**TOWN OF NEWBURGH
PLANNING BOARD
TECHNICAL REVIEW COMMENTS**

PROJECT: HANOVER ROUTE 32 SUBDIVISION
PROJECT NO.: 21-06
PROJECT LOCATION: SECTION 2, BLOCK 1, LOT 57.2
REVIEW DATE: 14 MAY 2021
MEETING DATE: 20 MAY 2021
PROJECT REPRESENTATIVE: ENGINEERING AND SURVEYING PROPERTIES

**RE: W.O. # 1051.11
PB APPLICATION 2021-06
HANOVER RTE 32 SUBDIVISION
TAX LOT # 2-1-57.2
COMMENT RESPONSE**

C-300

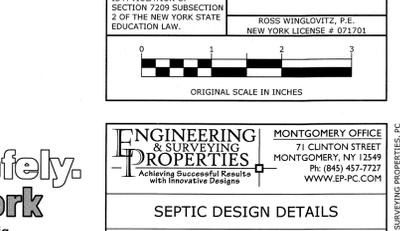
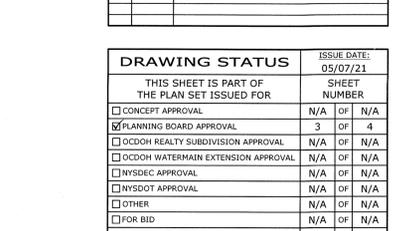
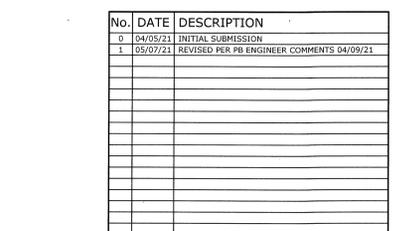
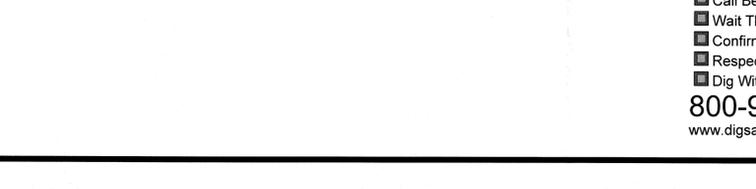
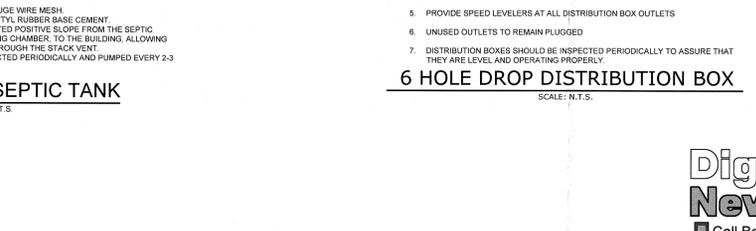
1. The Applicants have revised the subsurface sanitary sewer disposal system on Lot #3 to provide separation distances from the Federal Jurisdictional Wetland area.

5. The septic system location on proposed Lot 3 has been relocated so that it is more than 100 hundred feet away from the existing wetlands.
6. The septic system location on proposed Lot 3 has been relocated. Please refer to Sheet C-300 for the corresponding percolation and deep test pit results.
